mercruiser STERNDRIVES & INBOARDS

No. 98-16

Revised January, 1999. This bulletin supersedes all of the following bulletins 94-1, 94-16, 96-1 and 97-7.

Bravo Drive Shaft Housing Replacement

a - Bravo One / Two Standard Insert Location
b - Bravo One / Two Optional Insert Location

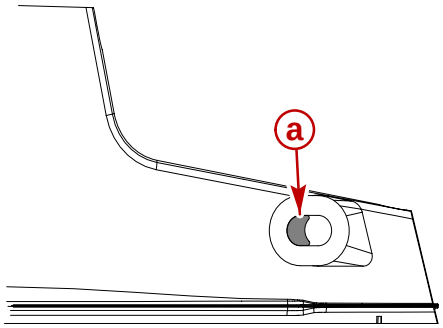
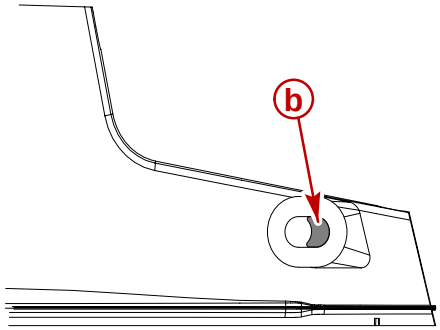
The 1589-8868A25 and 1589-8868A55 drive shaft housings will supersede to the 1589-8868G21 drive shaft housing. The anchor pin hole changes from the round aft anchor pin hole to the elongated (slotted) aft anchor pin hole. The elongated (slotted) aft anchor pin hole requires the use of a crescent shaped insert (808006). This insert is included with the housing to position the pin placement for Bravo One / Two / Three.

For the Bravo One and Two, the insert is placed in the **FORWARD most position** in the aft anchor pin hole. This placement will give the normal minus 5 degrees of trim under. The insert may be placed in the **AFT most position** of the slotted hole to limit the amount of trim under for boat hulls requiring less trim under.

a - Trim-In Limit Spacer Location

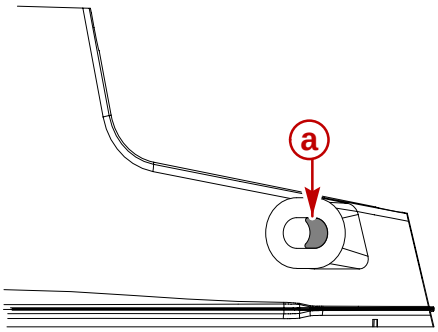
For the Bravo Three drive unit, the insert **MUST BE** placed in the **AFT most position** in the slotted hole to limit the Trim Under.

When the 1589-8868G21 housing is used on a Bravo Three drive unit, the Trim-In Limit Blocks (806692A2) will no longer be required. **DO NOT** reinstall them on the drive unit. If the blocks are already installed, they **MUST BE REMOVED**.

After placing the insert in the AFT most position of the slotted hole, install a Tilt Limit Spacer Kit (15768A3). Use 1 spacer per cylinder as shown below to prevent the bell housing and drive shaft housing from contacting the gimbal ring U-Bolt.
